THE SHELL — REV L

LINE THE ROOMS UP YOURSELF

REV L · 22 SEP 2026 8:21 AM · TO SCALE, 11 PX PER FOOT
ANCHORED ON THE 12×24 GARAGE

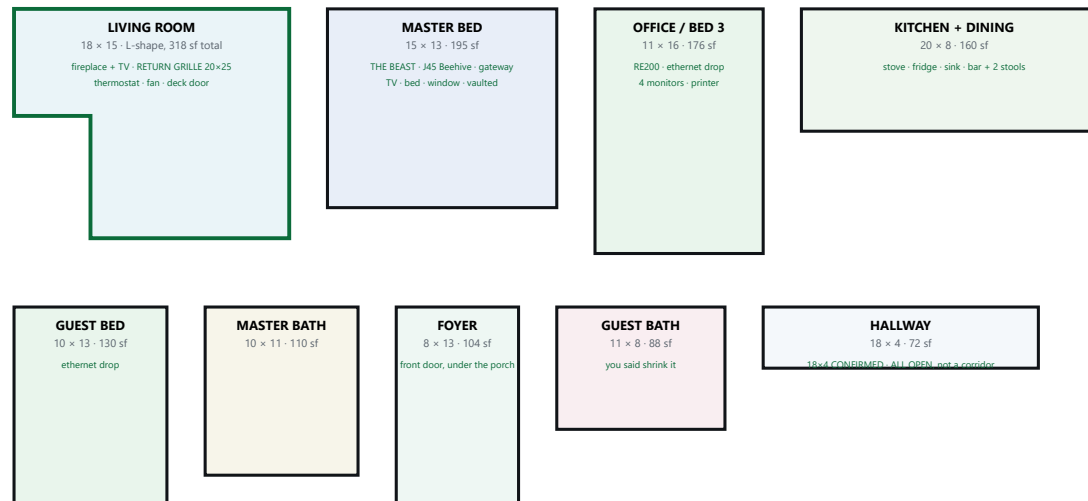
- **Staying as-is:** master bath 6", **guest bedroom 7"**, **office 6"**, guest bath 6".
- 💡 **Guest bedroom gets a 7" and the office a 6"** — so the contractor who sized that duct treated the **guest bedroom as the larger room of the two**. My tiles have the office bigger. One of us is wrong, and it is probably me.

⚠️ **The one thing still unresolved — the two doors.**

You said the **guest bedroom and office doors are straight across from each other**. With the hallway running **east–west** they cannot be — the guest bed is on its north side and the office is off its east end, so those doors are around a corner from each other.

They face each other if the hallway's **18 ft runs north–south** instead: a **4 ft wide, 18 ft long** spine with the guest bed on one side and the office on the other. **Same two numbers, turned 90°**. Slide the hallway tile either way on this sheet and it will tell you immediately.
